Docket No. 50-537
HQ:E:82:025

July 28, 1982

AMENDMENT NO. XV TO THE ENVIRONMENTAL REPORT FOR THE CLINCH RIVER BREEDER REACTOR PLANT

Figure 3.6-1 CHEMICAL AND BIOCIDES ADDITIONS AND DISCHARGES AT MAXIMUM POWER OPERATION

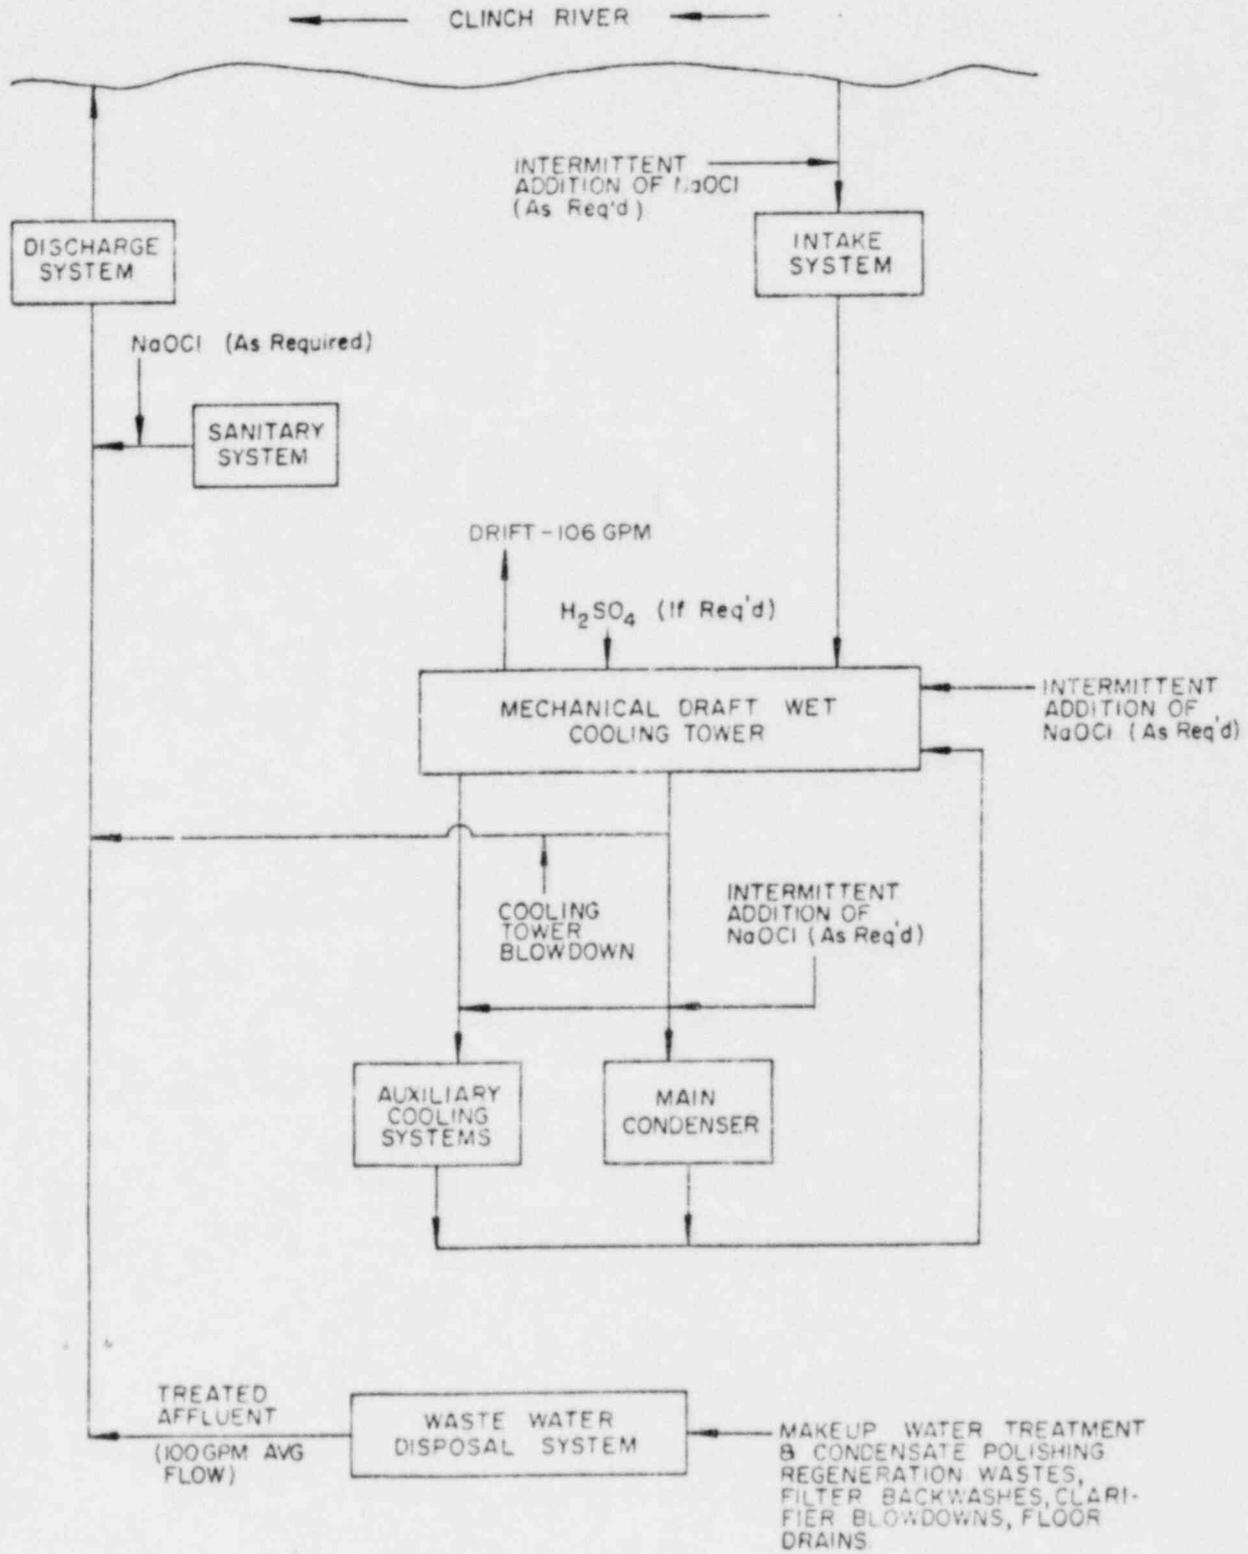
3.6.3	3.6-4	Deminer-eralizer	Delete limits on demineralizer chemicals.	Environmentally Inconsequential.
3.6.4	3.6-5	Sewage Disposal	Chlorine limits set to meet NPDES permit limits.	Environmentally Inconsequential.
Figure 3.6-1	3.6-7		Incorporate changes as described in text.	Environmentally Inconsequential.

FIGURE 4.1-1

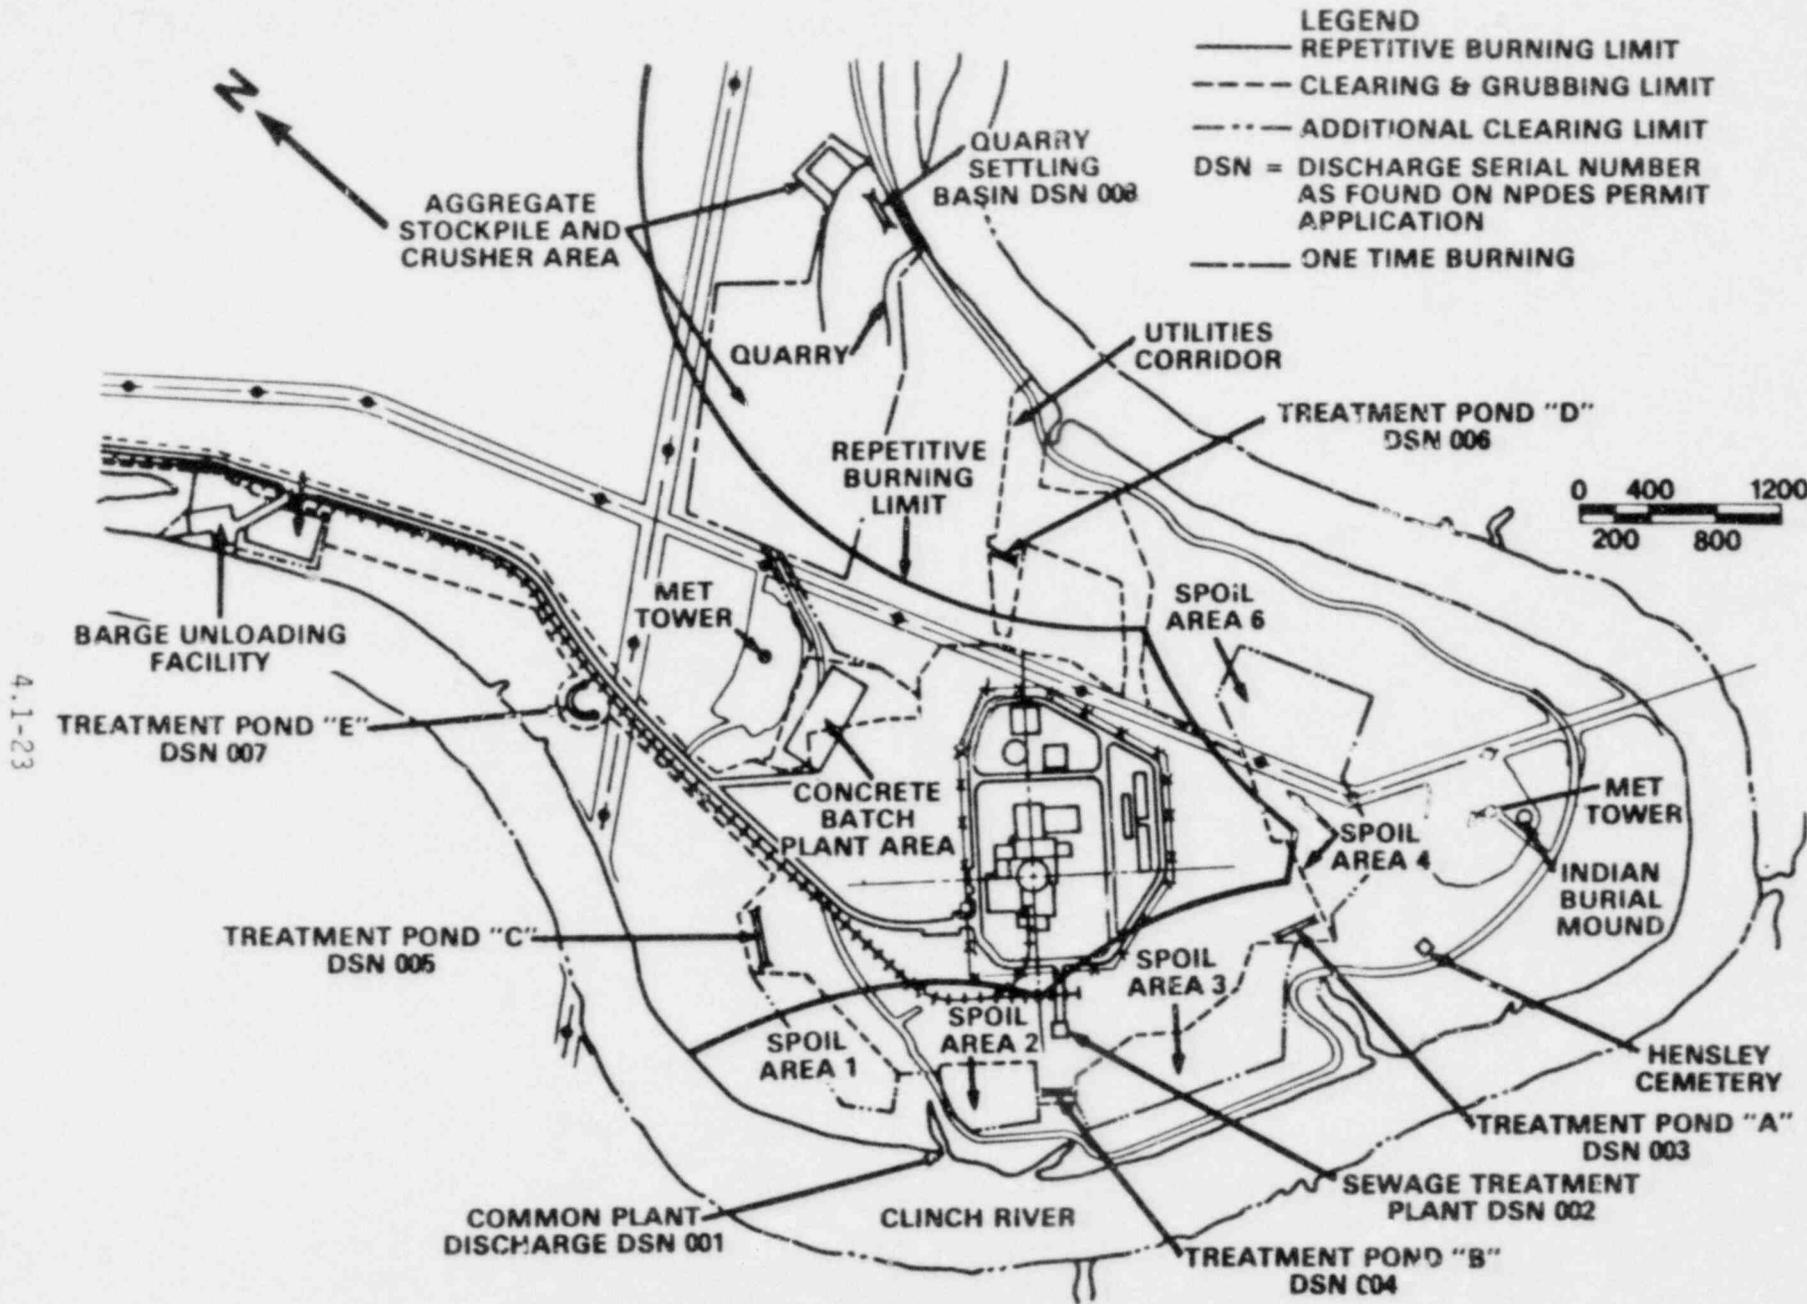
ER SECTION	REVISED	ITEM	DESCRIPTION OF CHANGE	ENVIRONMENTAL EFFECT
4.1	4.1-1, -2	Site Prep. and Plant Construction	Deletion of borrow area, Increase of site temporary acreage to 292 acres from 195 acres required for plant construction, 37 acres identified inside security barrier, quarry increase from 25 acres to 45 acres, provide crusher facility at quarry (Table 4.1-1, Figure 4.1-1).	Environmentally Inconsequential.

Figure 2.5-5 Site Geologic and Physiographic Map

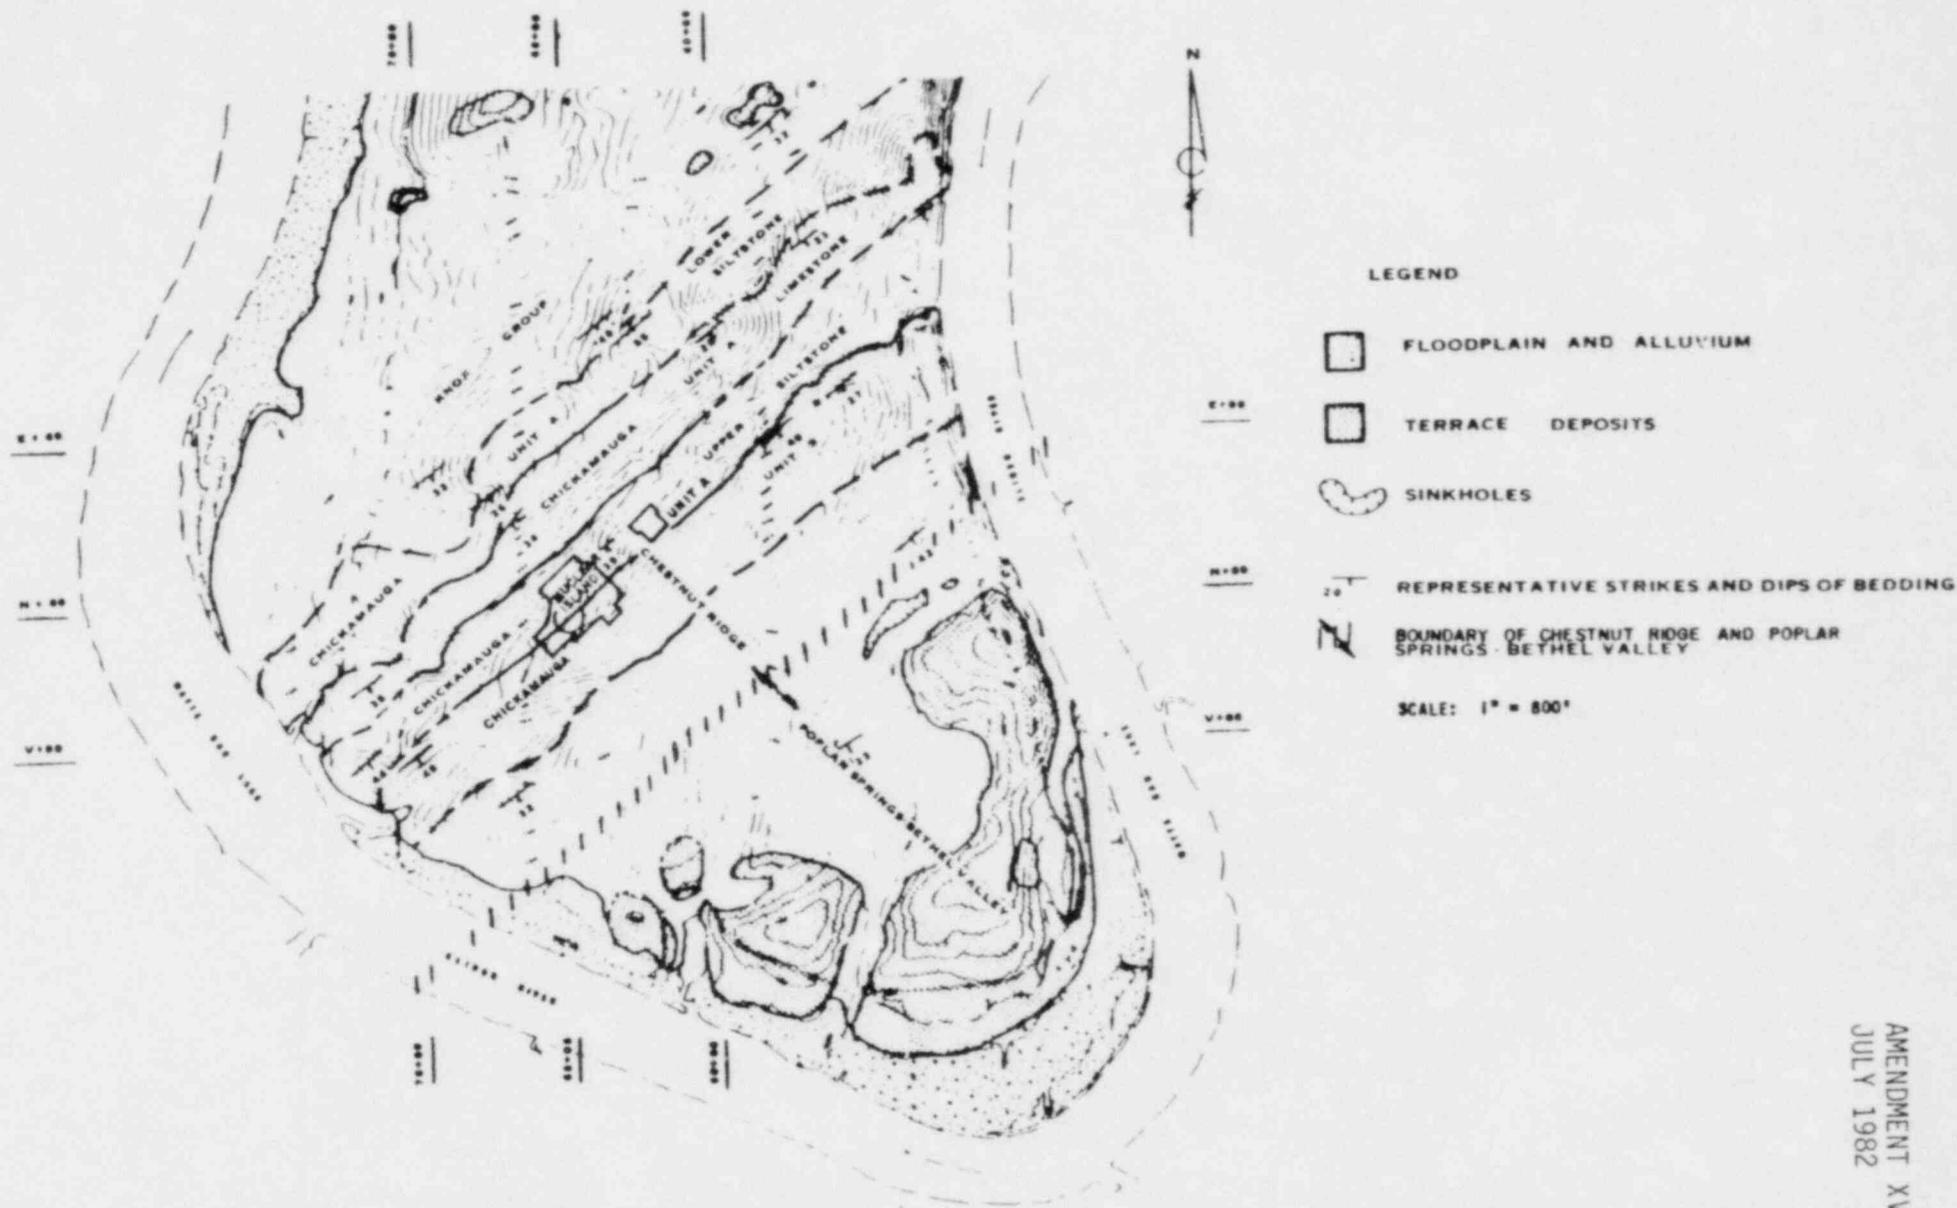
In response to this question we are providing Figure 2.5-5 from the PSAR which is the site geologic map.
